CORRIGENDUM-1

Ref: TPCODL/P&S/105/2020-21/Corrigendum/001

Subject: Replies to Pre-bid queries, Addition/Modification to Payment terms and Technical Specification of Tender number TPCODL/P&S/105/2020-21

Reference Document- Our Tender number TPCODL/P&S/105/2020-21 for Rate contract for Refurbishment work of 33/11KV Grid Sub-station across TPCODL area.

ANNEXURE-A-REPLIES TO PRE-BID QUERIES

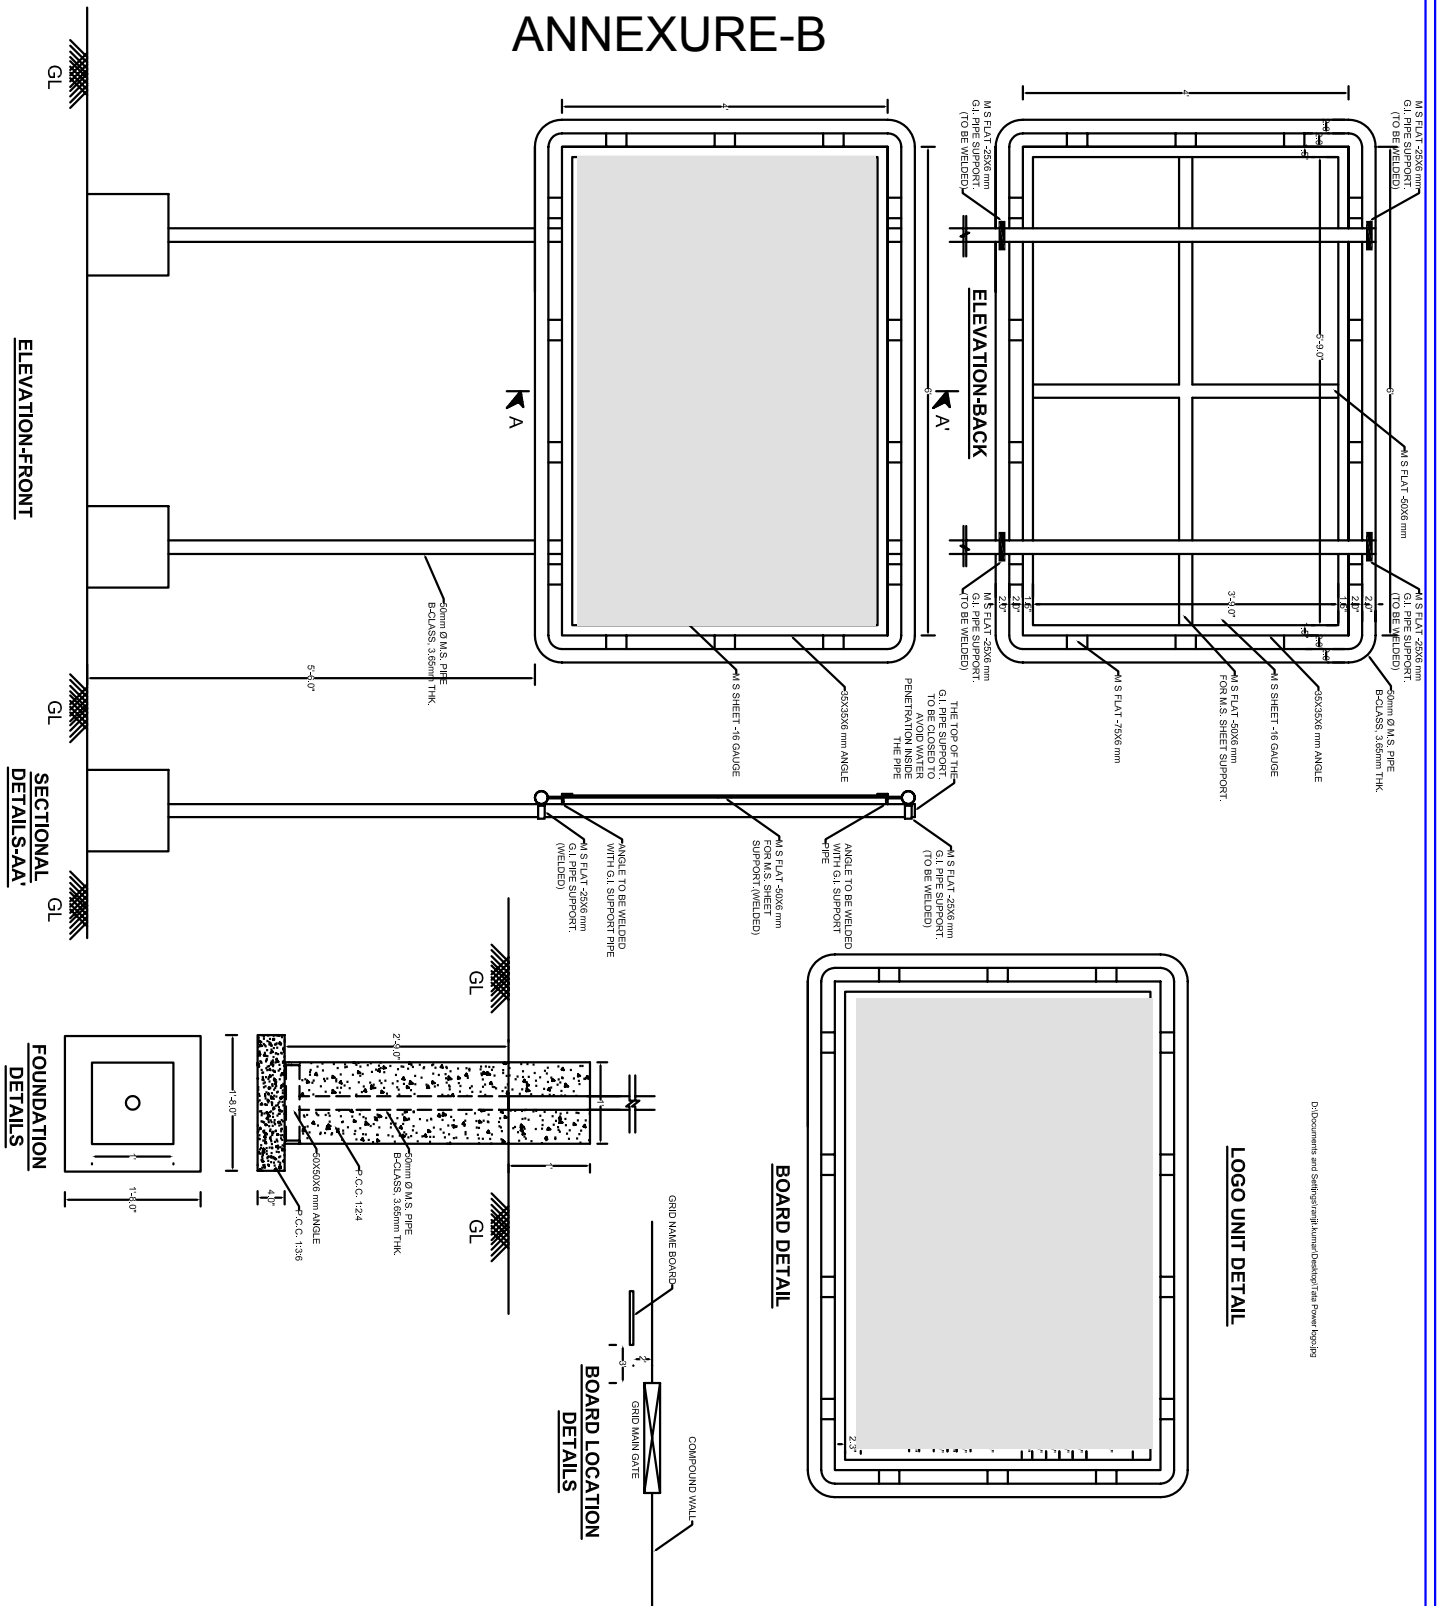
Sr. No.	Detailed Reference to Tata Power Technical Document	Description as per Bid Document	Remarks - Query / Clarification	TPCODL RESPONSE
1	BOQ Line item No-1	<p>Installation, testing & commissioning of 36KV ,2000A, 25KA for 3 secs, vacuum Circuit Breaker, 3 Ph gang operated complete with operating mechanism, GI structure, grouting works and other accessories as per the approved drawing. All the Electrical and mechanical interlock of breaker should be available in working condition and should be checked before commissioning. The duty cycle of CBs installed in 33 kV System of the Concessionaire shall be "O-0.3 sec-CO-3 min-CO". The Surge Arrester shall be suitable for such circuit breaker duties in the system including jumpering/connections. this item also includes ITC of castle key & interlocking arrangement for breakers & isolators supplied with the equipment. this includes laying and termination of control cable with suitable glands(control cable vary from 4 Core to 12 Core 2.5 sqmm PVC armoured) , vermin proofing ,</p>	<ol style="list-style-type: none"> 1. We understand that GI Structure shall be supplied by TPCODL and erection of same is covered under this item. 2. We understand Earthing material shall be supplied by TPCODL and erection of same including is in scope and same is covered under this item. 3. we understand all accessories and items required for successful commission of VCB shall be supplied by TPCODL and contractor has to do erection work only 4. we understand that supply and termination of cable gland shall be paid under relevant item in BOQ. 5. we understand that laying of control/power cable shall be paid under relevant item in BOQ. 6. Also please clear Division where these quantity are required to install. 	<ol style="list-style-type: none"> 1. Generally OEM provide all items in supply. However, additional GI angle or channel required shall be provided by the bidder and shall be as per rates quoted in respective Line item (structural steel work) of the BoQ. Note- Complete installation is in Bidders scope. 2. New earthing is not in the scope, however existing earthing extension for newly installed / replaced equipment is in scope of work. 3. All accessories excluding CB and packed items are in scope of Bidder for successful commissioning of CB. control cable is in the scope of TPCODL. 4. Yes 5. Yes 6. it is in PAN TPCODL , as per prior requirement

Sr. No.	Detailed Reference to Tata Power Technical Document	Description as per Bid Document	Remarks - Query / Clarification	TPCODL RESPONSE
		nomenclature and earthing extension upto the mesh or nearest pit .		
2	BOQ Line item No-2	Installation, testing & commissioning of 11KV ,600A, 25KA for 3 secs, outdoor vacuum Circuit Breaker with indoor CR panel, 3 Ph gang operated complete with operating mechanism, GI structure, grouting works and other accessories as per the approved drawing. All the Electrical and mechanical interlock of breaker should be available in working condition and should be checked before commissioning. This item also includes ITC of castle key & interlocking arrangement for breakers & isolators supplied with the equipment. this includes laying and termination of control cable with suitable glands(control cable vary from 4 Core to 12 Core 2.5 sqmm PVC armoured) , vermin proofing , nomenclature and earthing extension upto the mesh or nearest pit .	<ol style="list-style-type: none"> 1. We understand that GI Structure shall be supplied by TPCODL and erection of same is covered under this item. 2. We understand Earthing material shall be supplied by TPCODL and erection of same including is in scope and same is covered under this item. 3. we understand all accesories and items required for sucessful commission of VCB shall be supplied by TPCODL and contractor has to do erection work only 4. we understand that supply and termination of cable gland shall be paid under relevent item in BOQ. 5. we understand that laying of control/power cable shall be paid under relevent item in BOQ. 6. we understand that we have to do only erection of C&R Panel. Supply and erection of MS channel required for supporting of panel shall be provided TPCODL including earthing of panel if required. 	<ol style="list-style-type: none"> 1. Generally OEM provide all items in supply. However, additional GI angle or channel required shall be provided by the bidder and shall be as per rates quoted in respective Line item (structural steel work) of the BoQ. Note- Complete installation is in Bidders scope. 2. New earthing is not in the scope, however existing earthing extension for newly installed / replaced equipment is in scope of work. 3. All accessories excluding CB and packed items are in scope of Bidder for successful commissioning of CB. control cable is in the scope of TPCODL. 4. Yes 5. Yes 6. supply and erection of MS channel, extension of earthing from nearest panel are included in scope 7. it is in PAN TPCODL , as per prior requirement

Sr. No.	Detailed Reference to Tata Power Technical Document	Description as per Bid Document	Remarks - Query / Clarification	TPCODL RESPONSE
			7. Also please clear Division where these quantity are required to install.	
3	BOQ Line item No-3	Installation, testing and commissioning of 33KV Oil cooled O/D CT as per TPCODL specification.	We understand Pipe Electrode -3 mtr shall be supplied by TPCODL at site and erection of same including civil work and making of chamber is in scope and same is covered under this item.	NA
4	BOQ Line item No-33	Transportation of various items from TPCODL store/site to other site or vice versa in TPCODL operational area - Tempo 709 with labours as required (price per trip). Scope of work also include loading and unloading of materials except heavy items like HT Panel, Transformer, Cable Drum, LT Board where loading, unloading is to be done with crane and will be paid separately	Please mention the distance Range of transportation	30km (this is specific for this case only)

5	page no. 21 sl. No. 14 Annexure-1	SITC of asset numbering Drawing approval to be taken as per rules before erecting activity. Danger board are to be provided on fencing near the entry gates & at a distance of every 5 meters and turns on a height of 2.6 meters. Complete identification of all the assets/equipment's, RCC cable trench cover there marking in the approve color	"Complete identification of all the assets/equipment's, RCC cable trench cover there marking in the approve color and numbering to be done with detailed description of the asset as per the requirement of project in-charge. This includes supply of paints and other required material to complete the activity. (This item shall be paid per PTR	Identification will be done as name, numbers and color coding etc. as per TPCODL standard for complete Bay equipment (both outdoor/Indoor and all associated equipment) numbering and nomenclature will be considered for payment. RCC cable trench covers will only be numbered as per TPCODL standard

Sr. No.	Detailed Reference to Tata Power Technical Document	Description as per Bid Document	Remarks - Query / Clarification	TPCODL RESPONSE
		and numbering to be done with detailed description of the asset as per the requirement of project in-charge. This includes supply of paints and other required material to complete the activity. (This item shall be paid per PTR Bay/ Line Bay,)	Bay/ Line Bay,)" Whether identification will be done in nos. or material name. How u need the detail description of the assets, pls mention. pls clarify PTR Bay/ Line Bay Paid. Mention RCC & CABLE trench specification & required in a LOT .	irrespective of size and specs. We estimate the average number of Trench covers to be between 40-50 nos. per lot.
6	page no. 21 sl. No. 15 Annexure-1	SITC of Grid sign boards. Within 10 days of award of order grid sign board is to be placed at site outside the grid. Location to be confirmed from the concerned project-in- charge. Installation, testing & commissioning of the same is covered in the scope of order. No special mention of the same is again required in the tender document. Drawing approval to be taken as per rules before erecting activity. Danger board are to be provided on fencing near the entry gates & at a distance of every 5 meters and turns on a height of 2.6 meters.(This item is only for Grid job Sign Board as per TPCODL Specs.)	pls. provide the tech. specification & drawing of Sign board & Danger board & specify the average no. of danger boards required in a LOT .	As per attached drawing and specs (Annexure-B), Content of the same will be shared later. On an average 20 nos. of Danger boards shall be required per lot.
